LINCOLN CITY/LANCASTER COUNTY PLANNING STAFF REPORT

for March 2, 2005 PLANNING COMMISSION MEETING

P.A.S.: Annexation #04003, Change of Zone #04019, Waterford Estates Preliminary Plat #04011

PROPOSAL: To preliminary plat 660 residential lots and 1 lot for a future school, to change the zone from AG, Agricultural to R-3, Residential and B-2, Planned Neighborhood Commercial and to annex approximately 300 acres, more or less.

WATERS OF THE U.S. MAP
Meginnis / Finke Property
Lancaster County, Nebraska

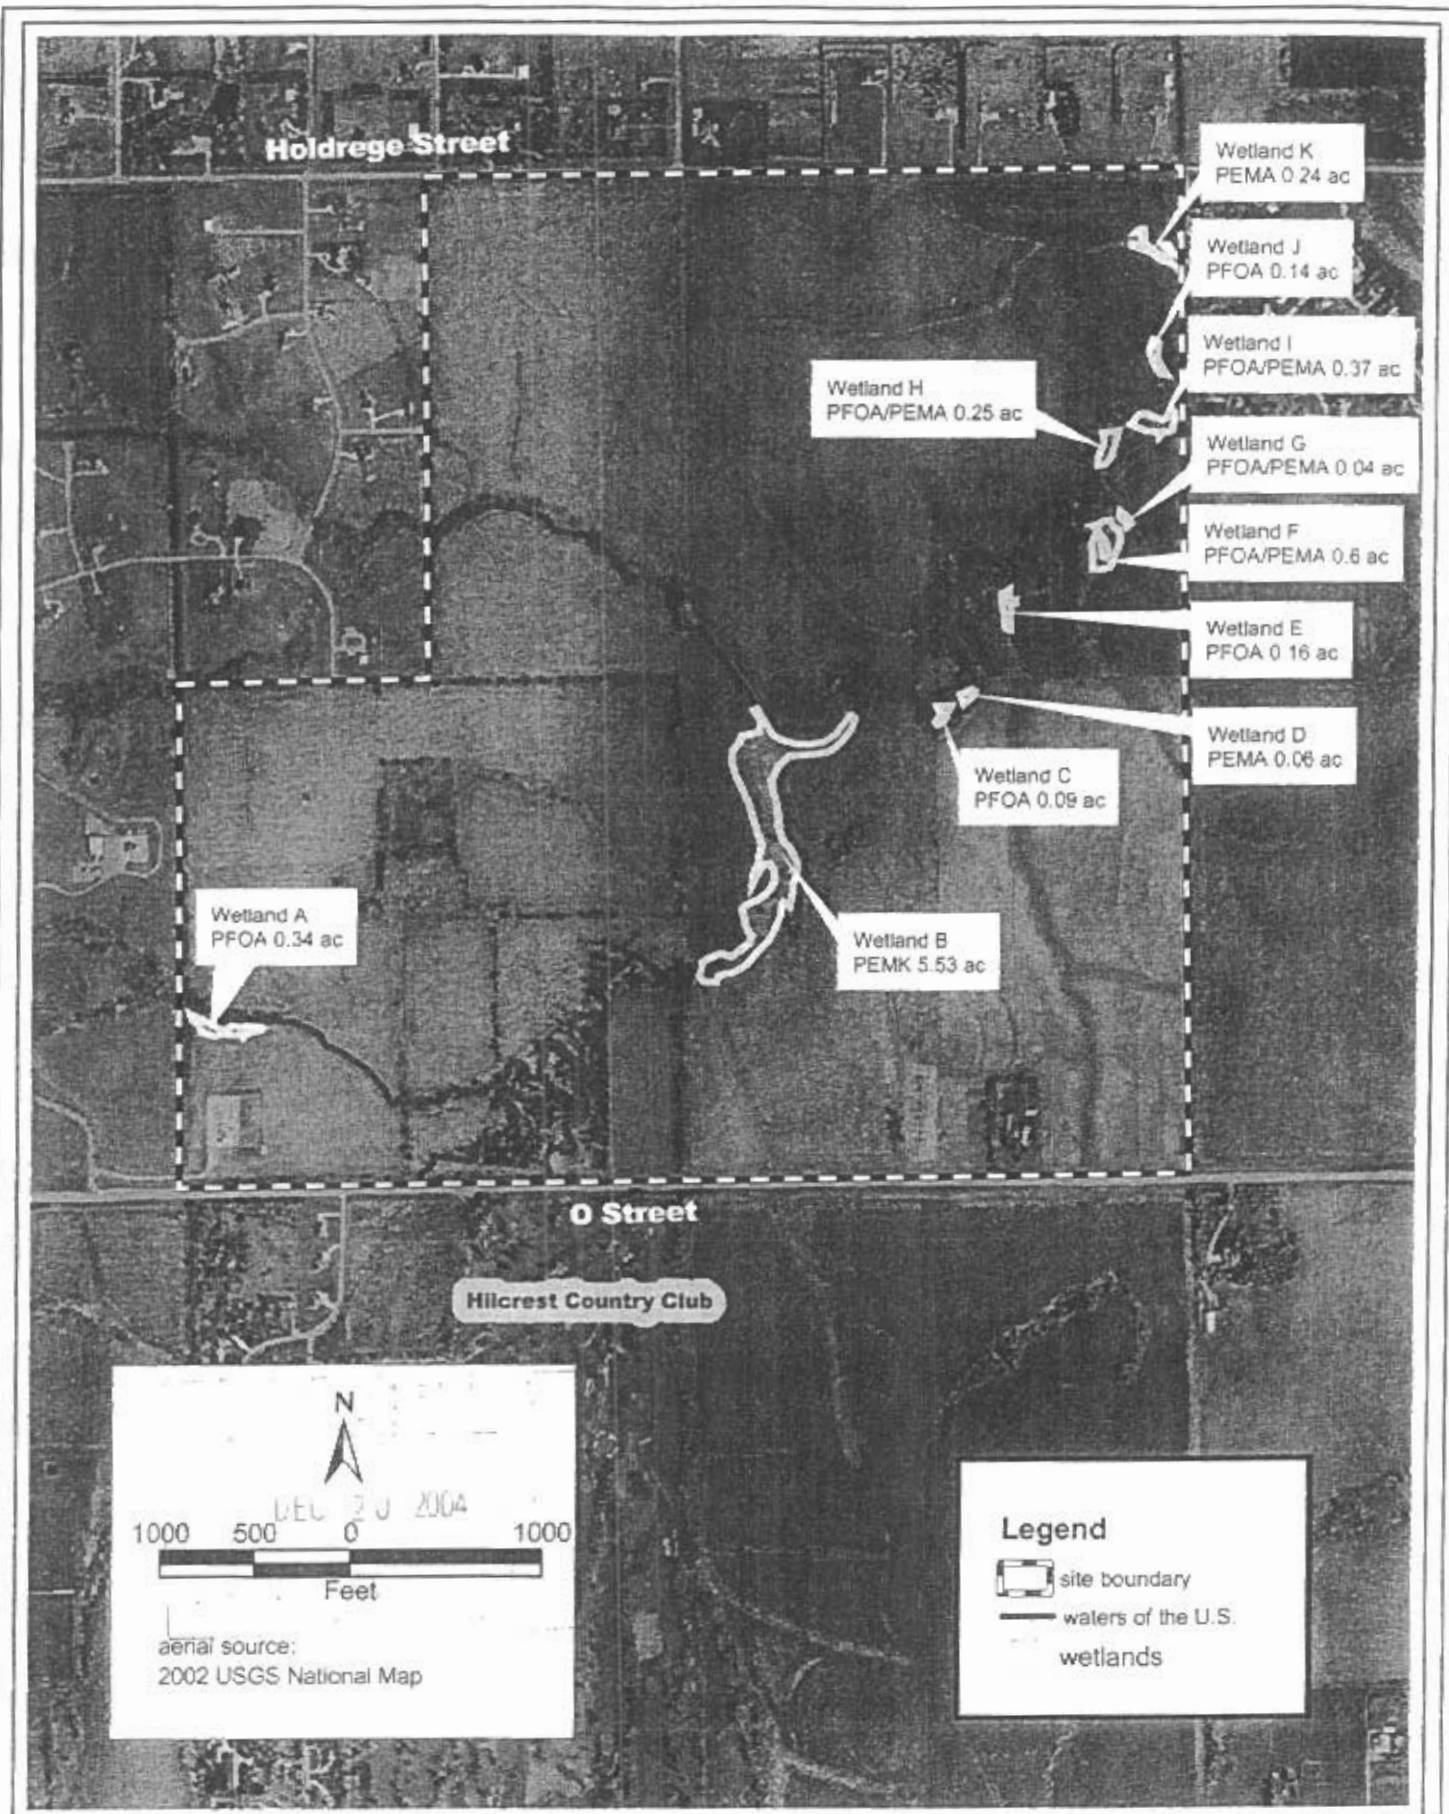
This channel is a farmed drainage swale. It is not delineated as a "Waters of the U.S." by the Corp of Engineers and does not have a defined bed and bank. There is no existing woodland vegetation along the swale. Historical photographs show this channel was not vegetated over the last 50 years. The swale does drain 150 acres of land and therefore falls within the City of Lincoln Minimum Flood Corridor requirements.

Mitigation: The channel is being relocated as shown in Exhibit 1. The relocated channel will be an engineered channel that is designed to minimize maintenance requirements. The minimum flood corridor easement will be dedicated on this mitigated channel. Because there was no existing wooded vegetation in the existing corridor, trees, shrubs, and native vegetation will be planted within the easement to mitigate impacts to other channels on the site. Approximately 1,190 linear feet of corridor is being relocated.
